REQUEST FOR COUNCIL ACTION

ITEM DESCRIPTION: General Development Plan #214 by Frank Kottschade to be known as Willow Creek Commons. The applicant is proposing to develop approximately 69 acres of land with a variety of land uses consisting of commercial and industrial uses. The property is located along the south side of 40th Street and along the west side of TH 63.

RE: General Development Plan #214 to be known as Willow Creek Commons

Project: Willow Creek Commons
 Date: 7/24/03
 Drawn: J. Jackson
 Checked: J. Jackson
 Title: GENERAL DEVELOPMENT PLAN

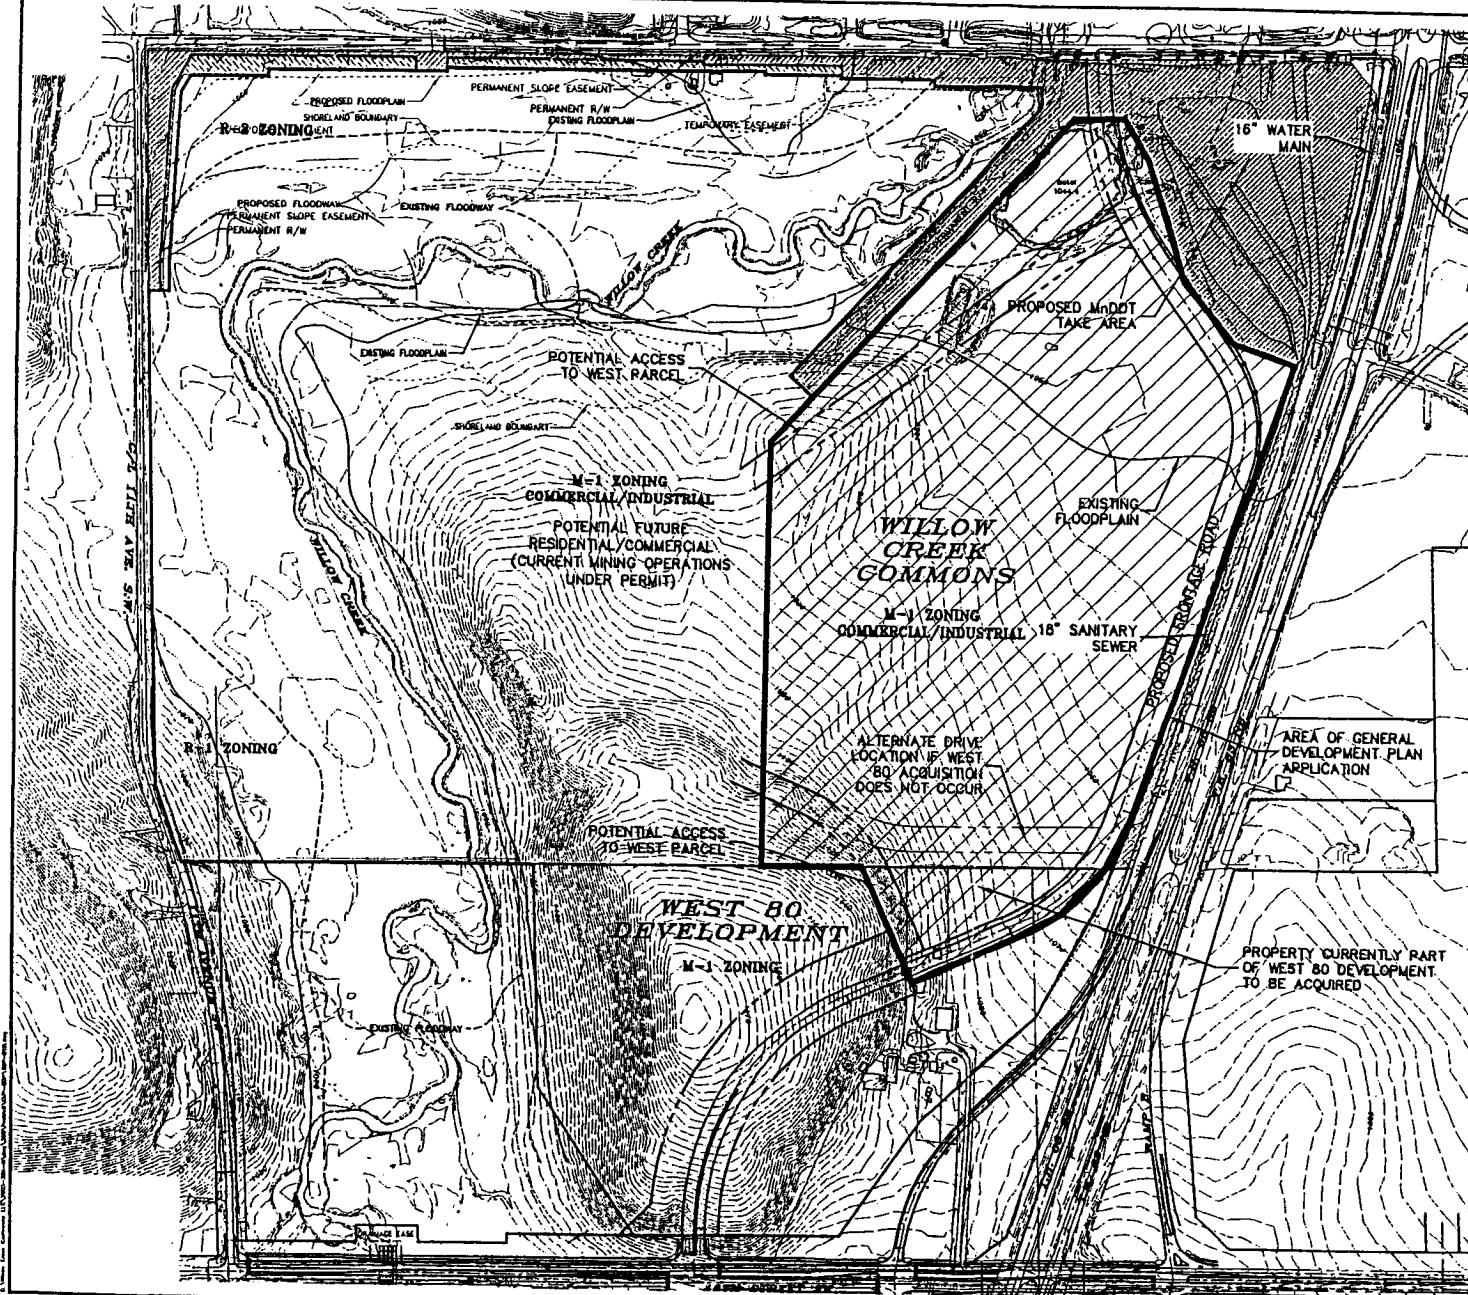
1. The General Development Plan shall be revised as follows, and a revised Plan shall be filed with the Planning Department:
 - ❖ Stormwater Management facilities must be shown and platted as outlots when platted.

- ❖ The "Alternate Drive" indicated at the south end of the Property should intersect perpendicular with the frontage road.
2. Prior to Final Plat submittal, Site Development Plan approval, and/or development of this Property, the applicant shall enter into a Development Agreement with the City that outlines the obligations of the applicant relating to, but not limited to, stormwater management, right-of-way dedication, transportation improvements, access control, pedestrian facilities, extension of utilities, and contributions for public infrastructure.

3. Stormwater Management facilities must be shown on the GDP. The MnDOT stormwater pond proposed for the southwest quadrant of T.H. 63 & 40th St SW has not been sized to accommodate post development stormwater flows from this Property. The development proposed will need to comply with City Land Development Standards for managing post development stormwater runoff quantities and quality. Any privately constructed detention facilities that serve less than 50 developable acres shall remain private, be platted on a separate Outlot(s), and will require the execution of an Ownership & Maintenance Agreement prior to Final Plat approval / and or development of the Property.

The "Alternate Drive" indicated at the south end of the property should intersect perpendicular with the frontage road.
